ATTACHMENT 3

Proposed Changes to the Technical Specifications  
for Implementing the New Requirements of 10CFR20

SOUTH TEXAS PROJECT  
UNITS 1 & 2

FIGURE 5.1-3  
UNRESTRICTED AREA\* AND SITE BOUNDARY FOR RADIOACTIVE GASEOUS EFFLUENTS  
(SEE ALSO FIGURE 5.1-4)

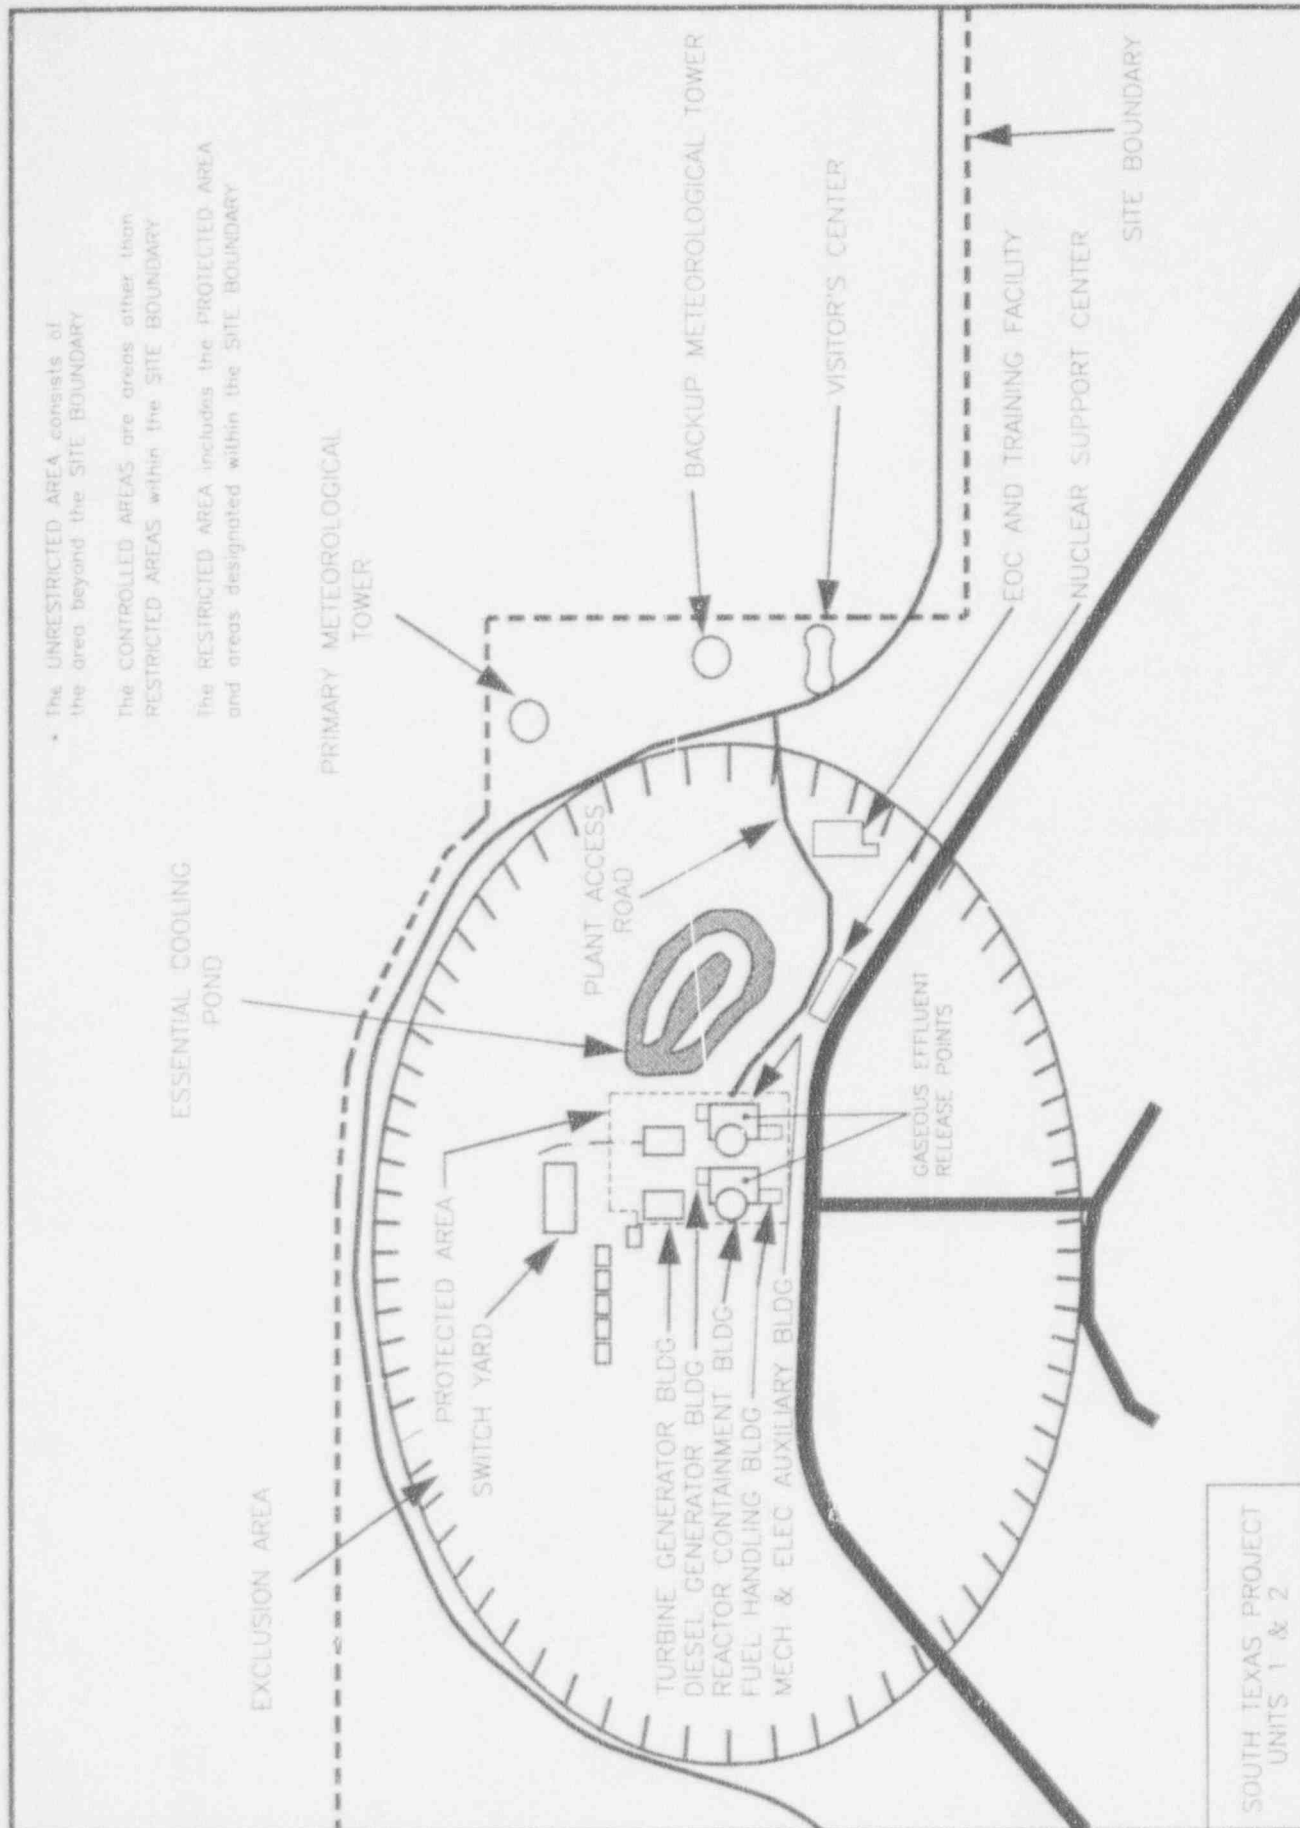
~~5.1.3 Information regarding radioactive gaseous and liquid effluents, which will allow identification of structures and release points as well as definition of UNRESTRICTED AREAS within the SITE BOUNDARY that are accessible to MEMBERS OF THE PUBLIC, shall be as shown in Figures 5.1-3 and 5.1-4.~~

~~The definition of UNRESTRICTED AREA used in implementing these Technical Specifications has been expanded over that in 10 CFR 20.3(a)(17). The UNRESTRICTED AREA boundary may coincide with the Exclusion (fenced) Area boundary, as defined in 10 CFR 100.3(a), but the UNRESTRICTED AREA does not include areas over water bodies. The concept of UNRESTRICTED AREAS, established at or beyond the SITE BOUNDARY, is utilized in the Limiting Conditions for Operation to keep levels of radioactive materials in liquid and gaseous effluents as low as is reasonably achievable, pursuant to 10 CFR 50.36a.~~

5.1.3 Figures 5.1-3 and 5.1-4 identify the gaseous effluent release points and illustrate the controlled area within the SITE BOUNDARY that is accessible to MEMBERS OF THE PUBLIC. The major structures within the restricted area are annotated as a point of reference. UNRESTRICTED AREA as defined in 10 CFR 20.1003 and established at or beyond the SITE BOUNDARY, is utilized in the Limiting Conditions for Operation to keep levels of radioactive materials in liquid and gaseous effluents as low as is reasonably achievable, pursuant to 10 CFR 50.36a.
